DA NO: DA-2014/332/B
ADDRESS: 8 THE RAMPART, CASTLECRAG NSW 2068.
PROPOSAL: INTERNAL CHANGES, INFILL OF VOID ALTERATION TO ROOF SHAPE, EXTRA SKYLIGHTS AND ASSOCIATED WORKS.
RECOMMENDATION: APPROVAL
ATTACHMENTS:
1. SCHEDULE OF CONDITIONS
2. SITE DESCRIPTION AND AERIAL PHOTO
3. DEVELOPMENT CONTROLS, STATISTICS, DEVELOPER CONTRIBUTION & REFERRALS
4. SUBMISSIONS TABLE
5. SECTION 4.55 (2) - ASSESSMENT
6. SECTION 4.15 (79C) ASSESSMENT
7. NOTIFICATION MAP
8. ARCHITECTURAL PLANS
RESPONSIBLE OFFICER: RITU SHANKAR (TEAM LEADER)
AUTHOR: JANE MCMILLAN – DEVELOPMENT ASSESSMENT OFFICER
MEETING DATE 26 MARCH 2019

The purpose of this report is to seek determination by Willoughby Local Planning Panel (WLPP) of Development Application DA-2014/332/B for internal changes, infill of void alteration to roof shape, extra skylights and associated works at 8 The Rampart, Castelcrag.

NORTH ELEVATION
1:100

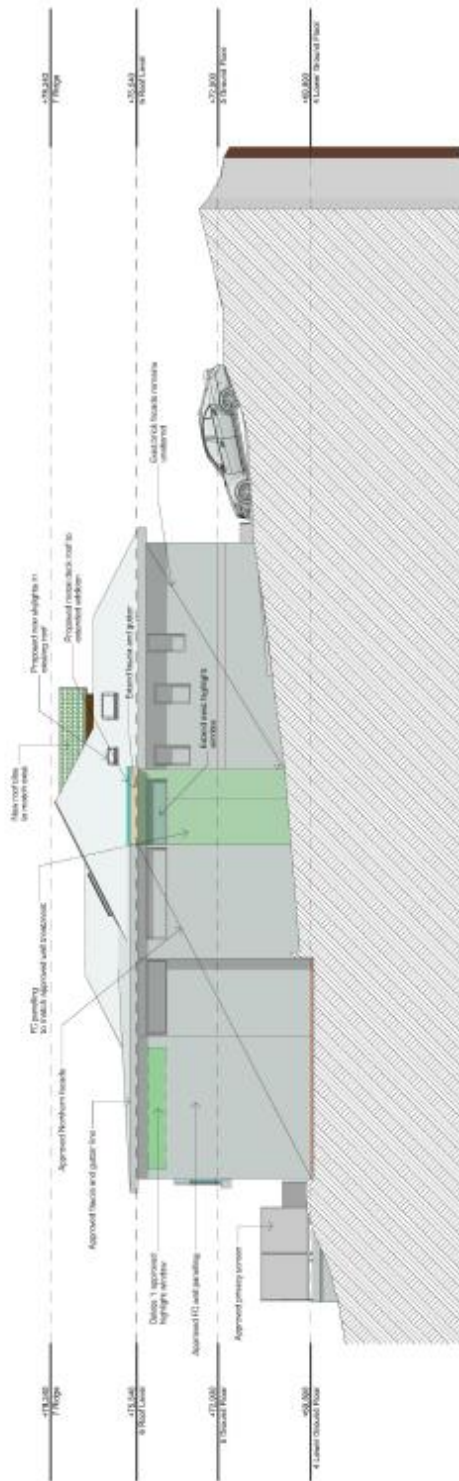
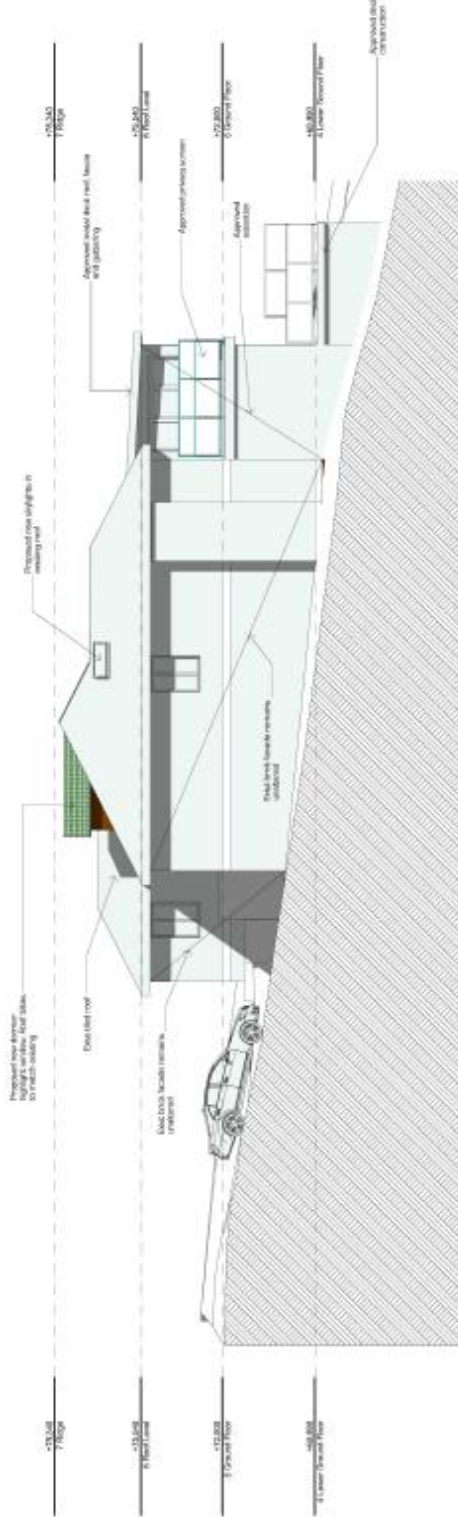
- Loss of sunlight and views as a result of wall extension on north-eastern elevation
- Non-compliance with building envelope due to wall extension on north-eastern elevation.
- Full length privacy screen for north-eastern elevation of lower ground floor deck required.
- Impacts of construction on Magnolia Tree located in proximity to the common boundary (at 6 The Rampart).

An analysis of the northern elevation plan shows that the additional wall length is located more towards the front of the site where the non-compliance with the building envelope is not significant. The side wall has a height of 4.8m at this point. The wall height increases to a maximum of 5.5m towards the rear of the site as per the already approved plans. The location of the proposed wall extension, on the south-western side of 6 The Rampart will not impact on views or sunlight to the rear garden of this adjoining property.

Issues raised	Response
6 The Rampart Castlecrag	
<p>1. The house is proposed to be extended by 1500mm along our south/western side boundary and has a non-compliance with the building height plane. Loss of views and sunlight as a result to our rear garden.</p>	<p>A plant room is added at the lower ground floor level, extending the length of the wall on the north-eastern elevation by 2.451m. This addition extends at the ground floor level as well for 2.451m. The wall extension maintains the existing side boundary setback of 1.53m.</p> <p>An analysis of the northern elevation plan shows that the additional wall length is located more towards the front of the site where the non-compliance with the building envelope is not significant. The side wall has a height of 4.8m at this point. The wall height increases to a maximum of 5.5m towards the rear of the site as per the already approved plans.</p> <p>The location of the proposed wall extension, on the south-western side of 6 the Rampart will not impact significantly on views or sunlight to the rear garden of 6 The Rampart.</p>
